# SERVICE BULLETIN

EC09-025

## VENT CONTROL VALVE REPLACEMENT

**APPLIED VEHICLES:** All Nissan models using Vent Control Valve  
P/Ns 14935-AM60A / AM60B

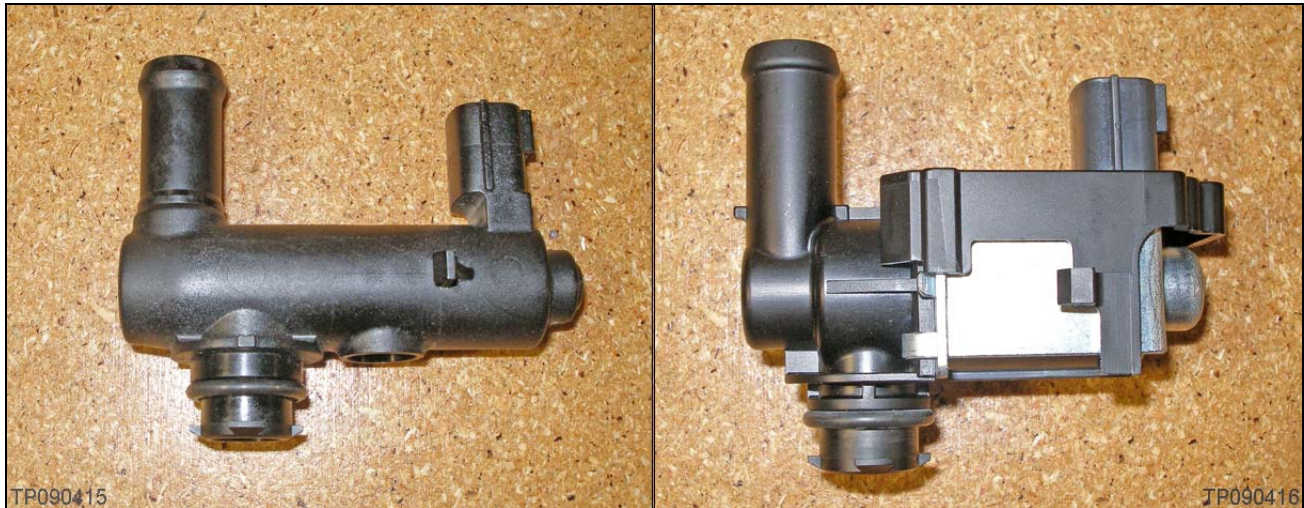
When replacing the EVAP canister vent control valve for any reason:

- Use the one listed in the **PARTS INFORMATION** section of this bulletin on Page 2.
- For vent control valve replacement procedure, refer to the appropriate section of the Electronic Service Manual (ESM) if needed.
- When installing the new valve, do not add any lube to its o-ring.
- For Frontier (D40 series) only: install the protector listed in **PARTS INFORMATION**.
  - For protector installation, see the **SERVICE PROCEDURE** section of this bulletin starting on Page 3.
- Make sure to use the “new style” valve listed in **PARTS INFORMATION**.

Old style vent control valve  
P/N 14935-AM60B

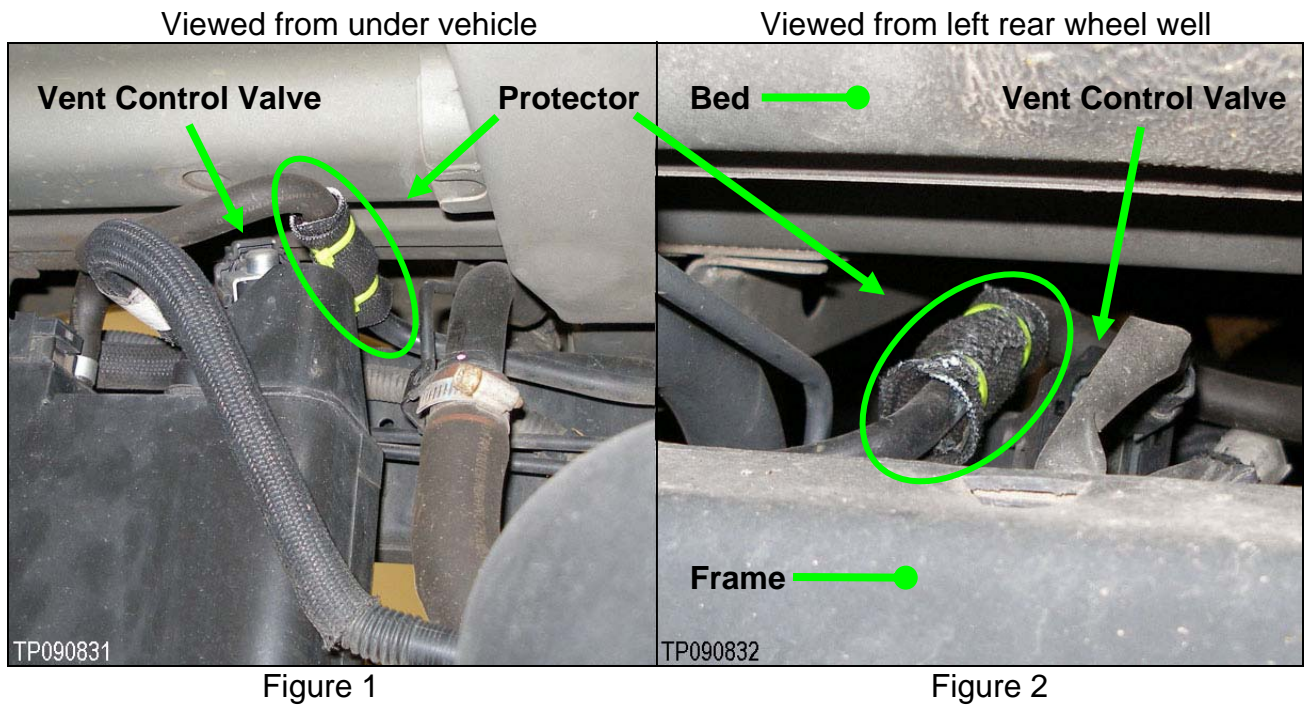
New style vent control valve  
P/N 14935-JF00A
